# Access Compliance Report

## Public Rights-of-Way

Intersection ID: 3506	Main Street: MT_HOLLY-HUNTERSVILLE_RD	Cross Street: BEATTIES_FORD_RD	Location: SW
ADA ID: 96FBAD6BF367	Ramp Type: Perp	Initial Pass/Fail: Fail	Overall Compliance: No
Severity Score: 8.75			
Codes/Mitigation Info/Possible Solution		Field Measurements/Component Compliance

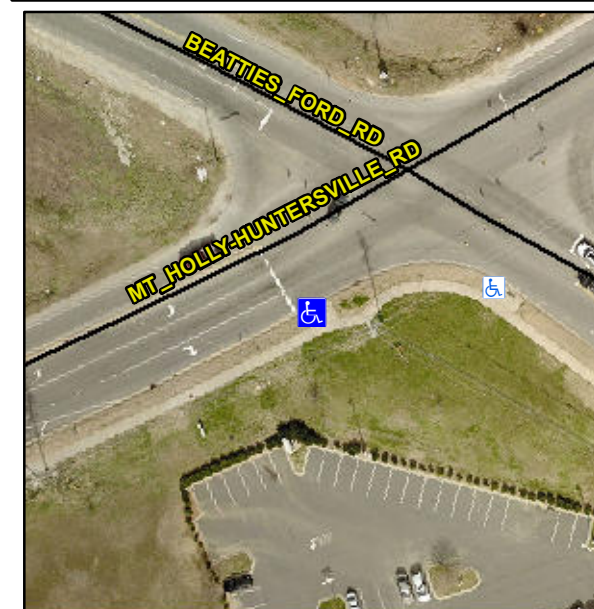
**Not Found, R304.5.1**

Compliance	Description	Data	Compliance	Description	Data
N/A	Ramp Length (in)	102.0	Yes	Ramp Slope (%)	5.5
No	Ramp Width (in)	47.0	Yes	Ramp XSlope (%)	1.3
N/A	Flare Type LT	N/A	N/A	Flare Type RT	N/A
N/A	Flare Slope LT (%)	N/A	N/A	Flare Slope RT (%)	N/A
N/A	Flare Traversable LT?	N/A	N/A	Flare Traversable RT?	N/A
N/A	Landing Length (in)	N/A	N/A	DWS Provided?	N/A
N/A	Landing Width (in)	N/A	N/A	DWS Contrast?	N/A
N/A	Landing Slope (%)	N/A	N/A	DWS Length (in)	N/A
N/A	Landing X Slope (%)	N/A	N/A	DWS Full Width?	N/A
N/A	Landing Curb? (Y/N)	N/A	N/A	DWS Offset (in)	N/A
N/A	Shared Landing?	N/A			
N/A	Gutter Ponding?	N/A	N/A	Gutter Slope (%)	N/A
N/A	Gutter Lip Ht (in)	N/A	N/A	Gutter X Slope (%)	N/A
N/A	Painted X Walk1?	No	N/A	Painted X Walk2?	N/A
	X Walk 1 Direction	To N		X Walk 2 Direction	N/A
N/A	X Walk 1 Width (in)	N/A	N/A	X Walk 2 Width (in)	N/A
	X Walk 1 Slope (%)	2.2		X Walk 2 Slope (%)	N/A
	X Walk 1 X Slope (%)	2.0		X Walk 2 X Slope (%)	N/A

**Remove & Replace Entire Ramp.**
